PLAN OF PROPOSED IMPROVEMENT

HILL VALLEY - PHASE 1

CITY PROJECT NO. 15668
CONTRACT NO. 9643

REVISION 1 - 9/ 17/ 2025

15668	MADISON, WI	9643	CONTRACT NO:
PLAN & PROFILE - S HIGH POINT RD			
HILL VALLEY - PHASE 1			
M:\DESIGN\Projects\15668\CAD\Streets\15668EN-PnP.dwg			
15668			
P-12

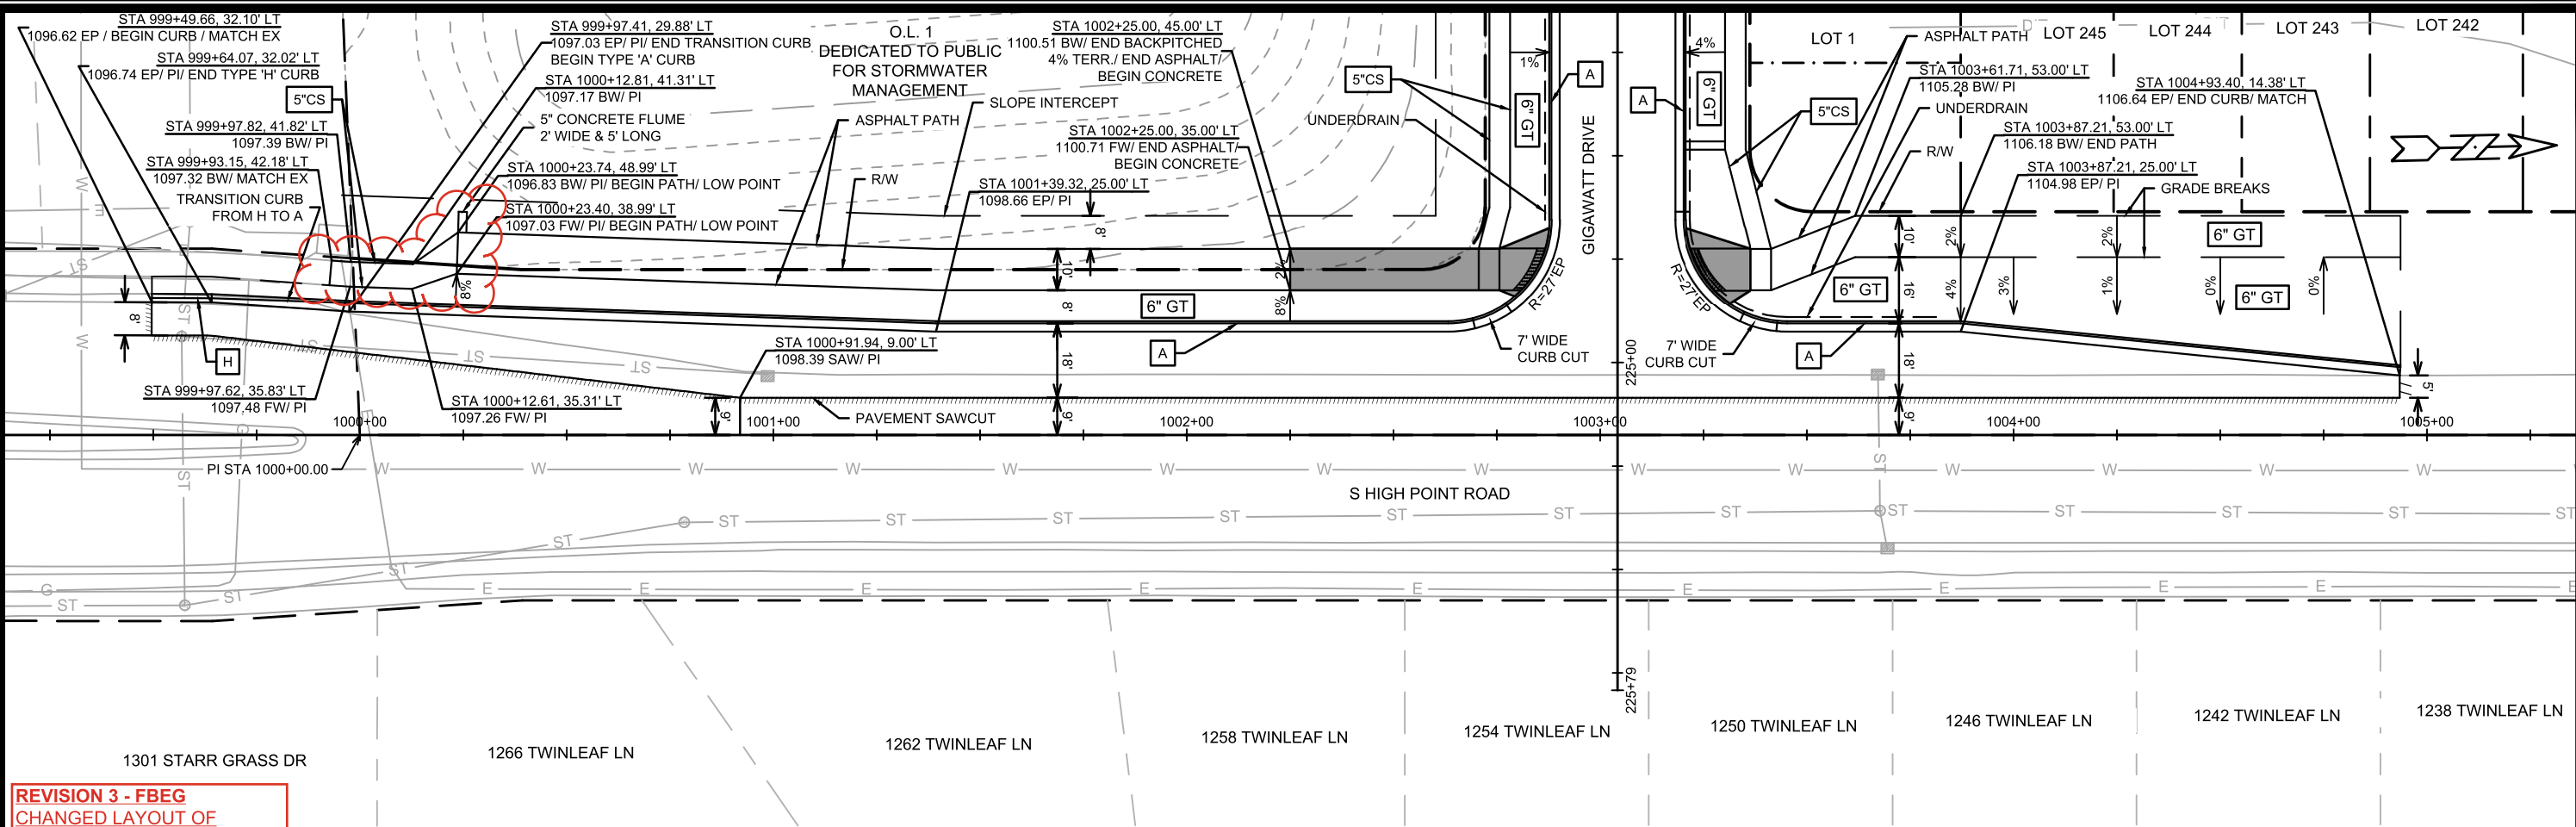
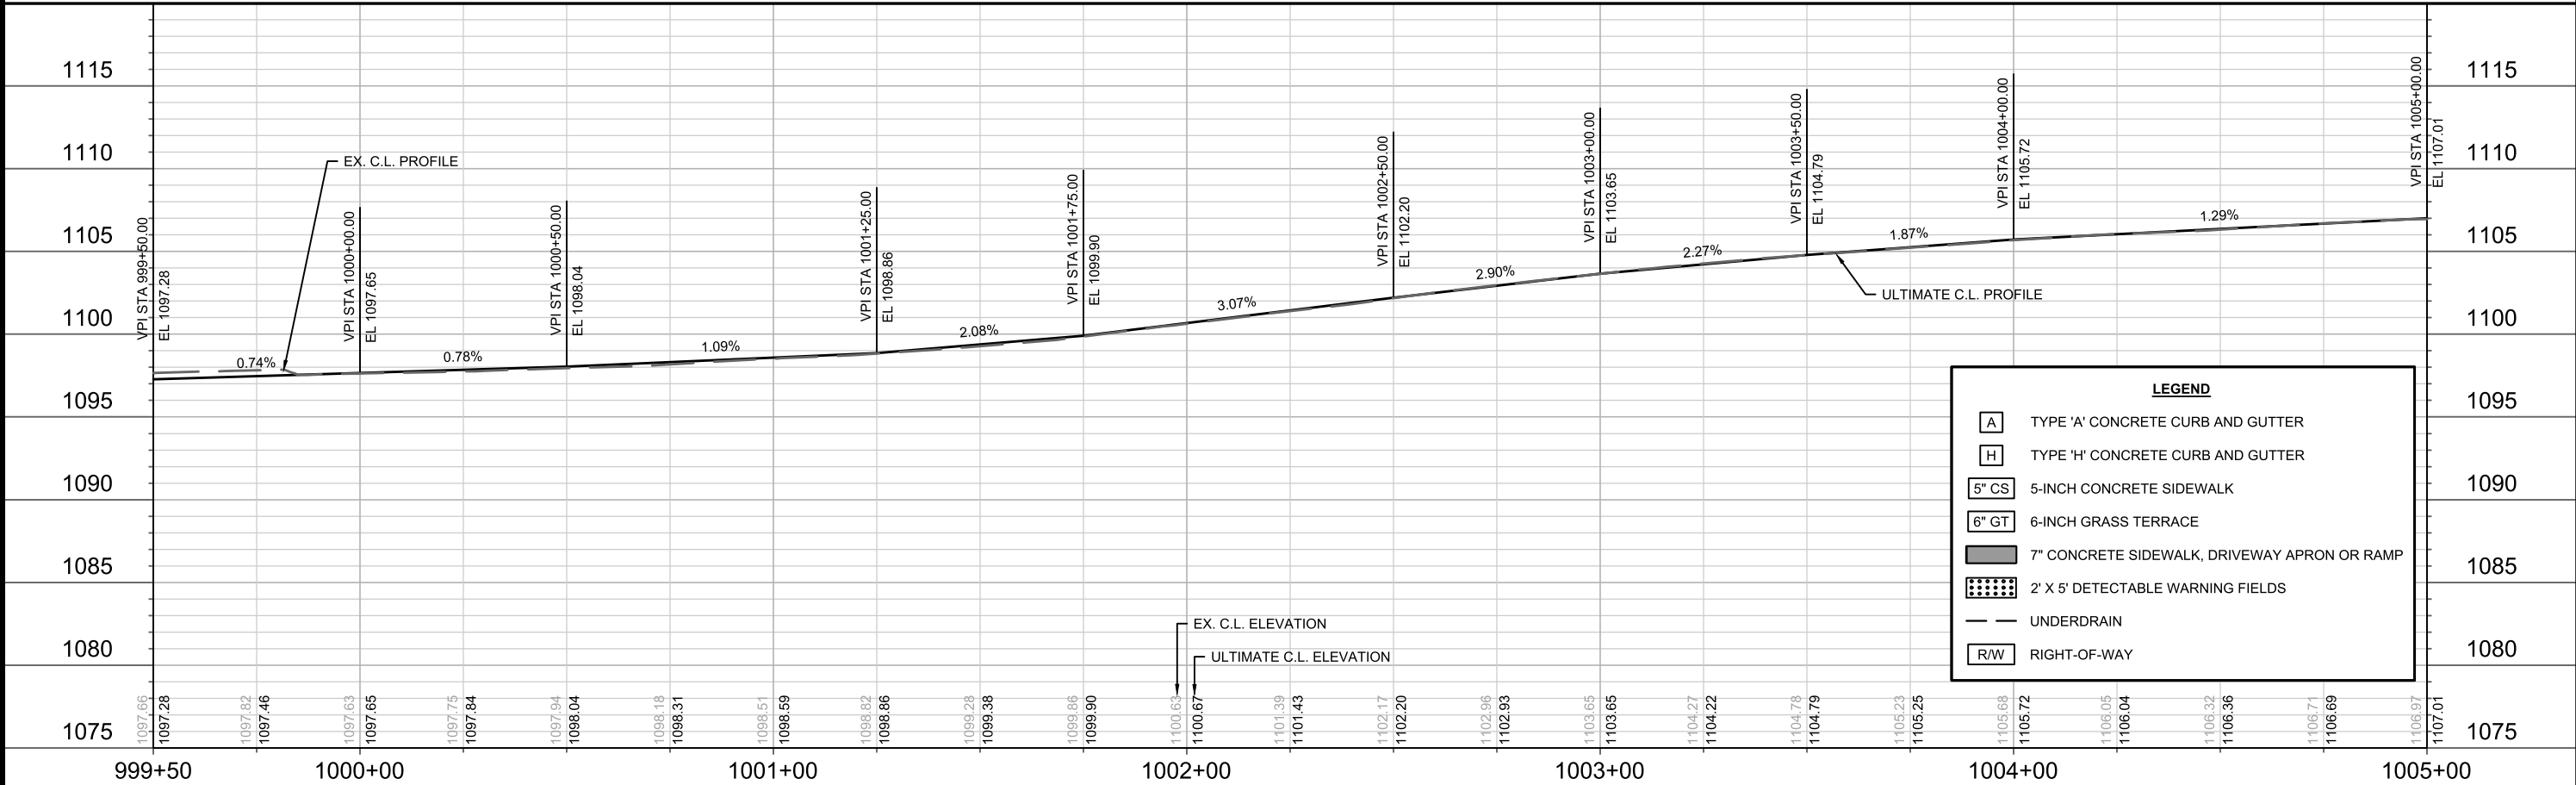
REVISION 3 - FBEG
CHANGED LAYOUT OF
SIDEWALK AND CONNECTION
LOCATION TO PATH.

P-13

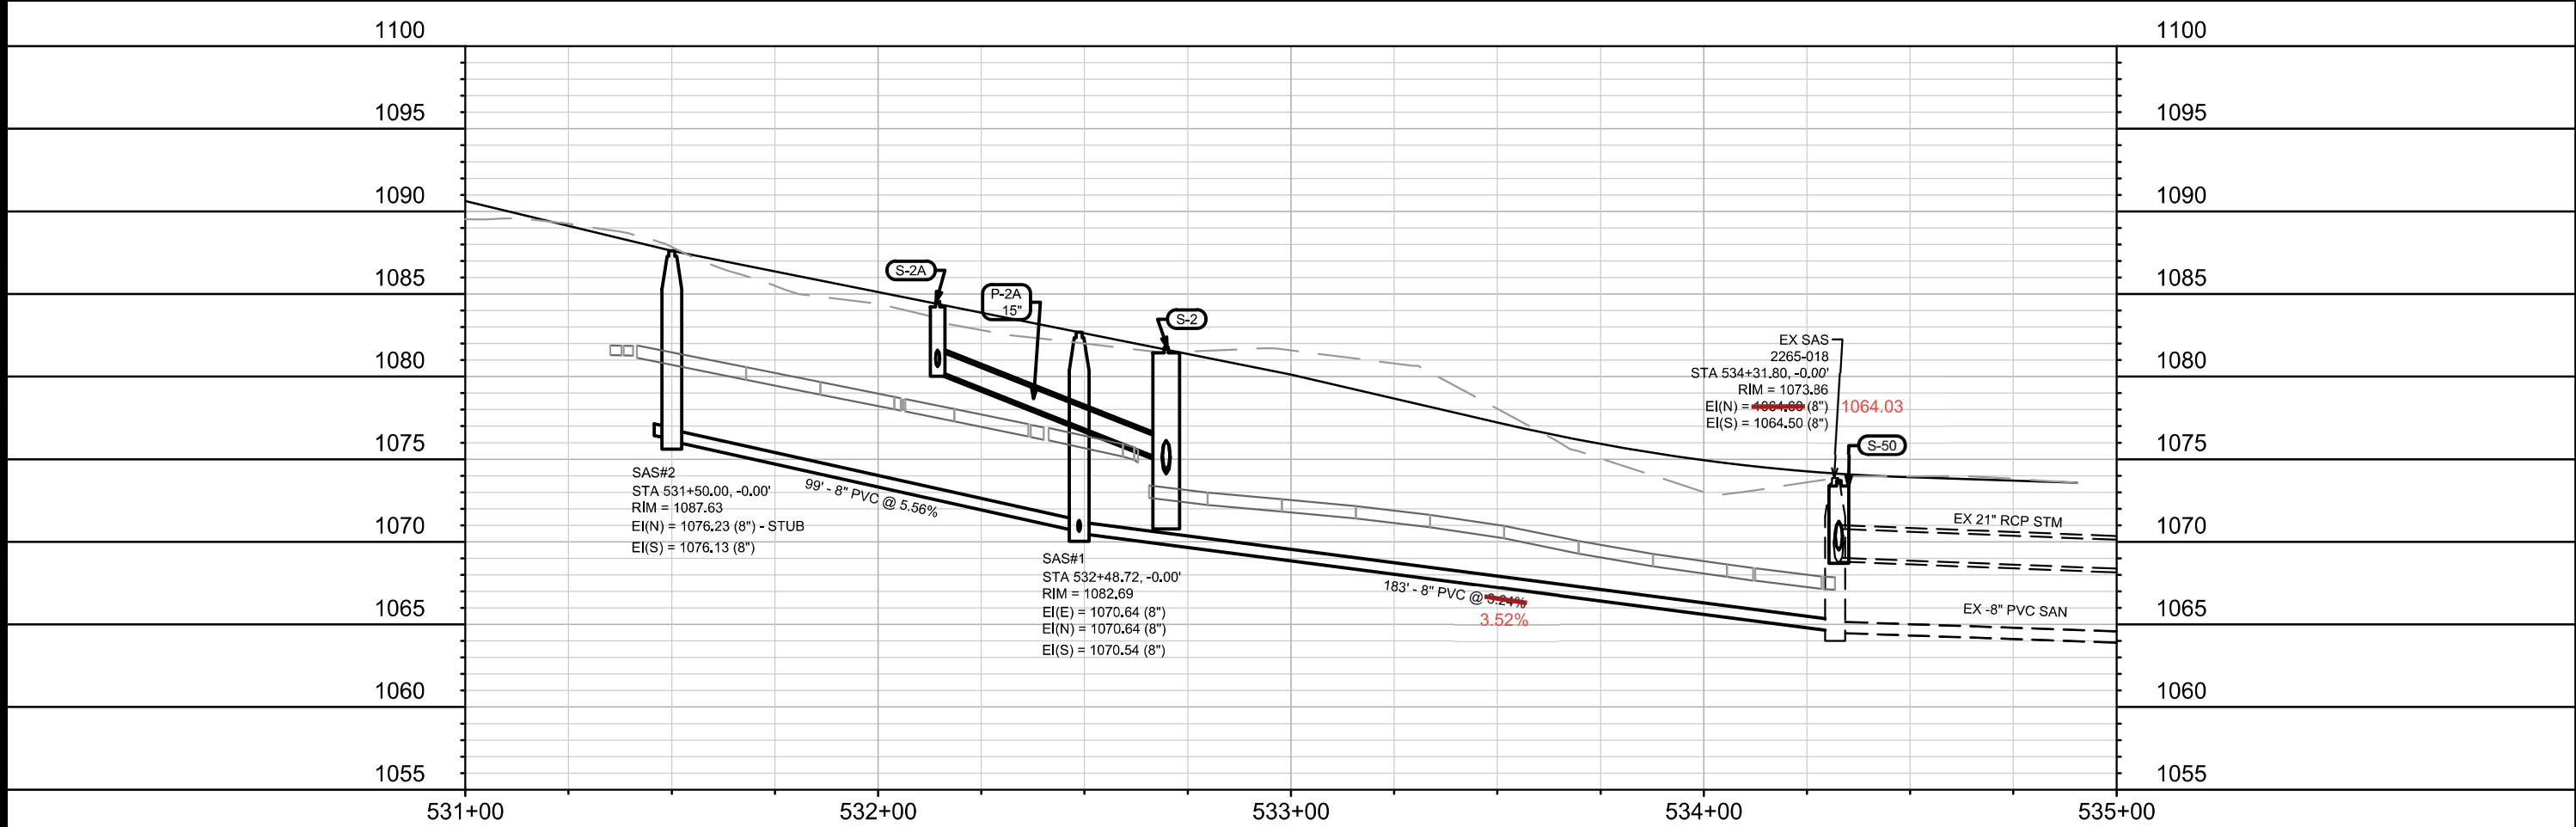
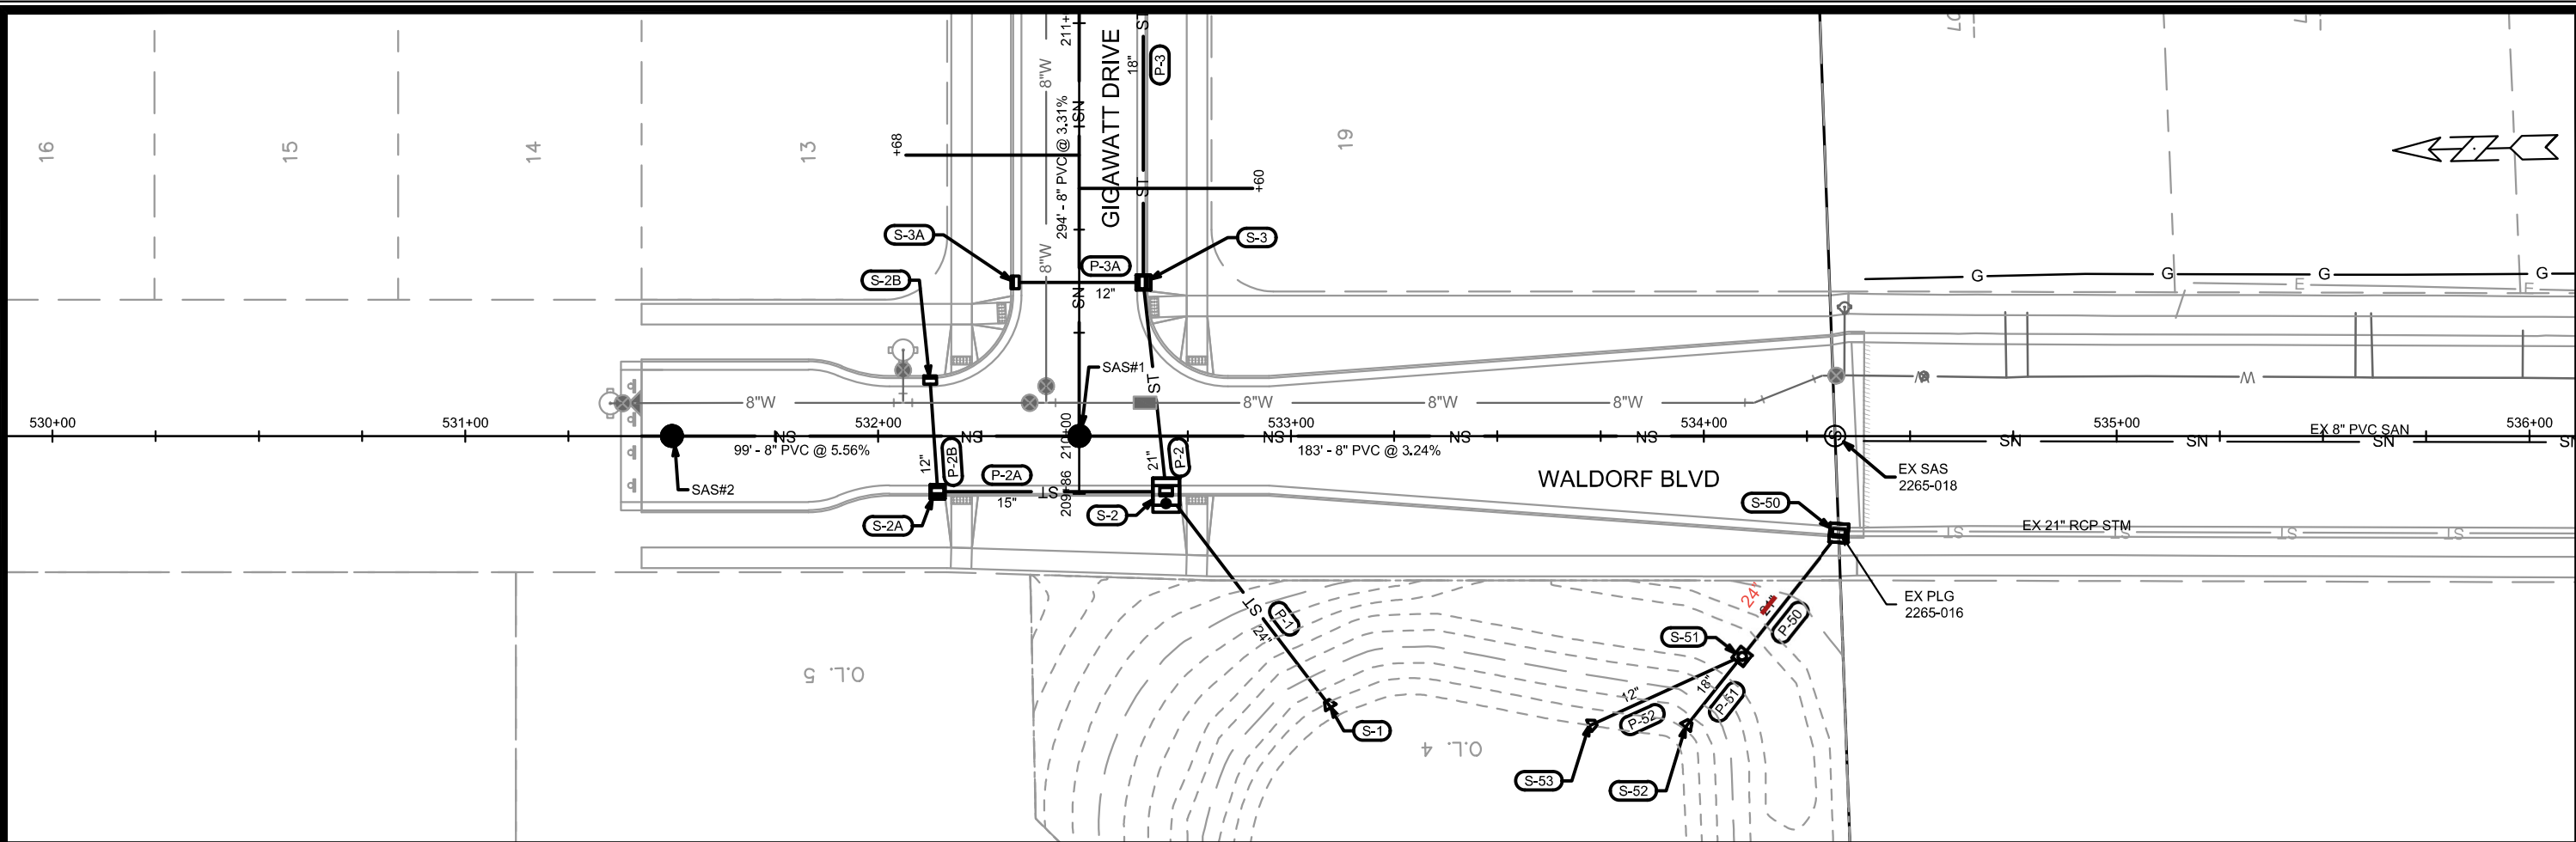
REVISION 1 - GCIT
SHEET ADDED
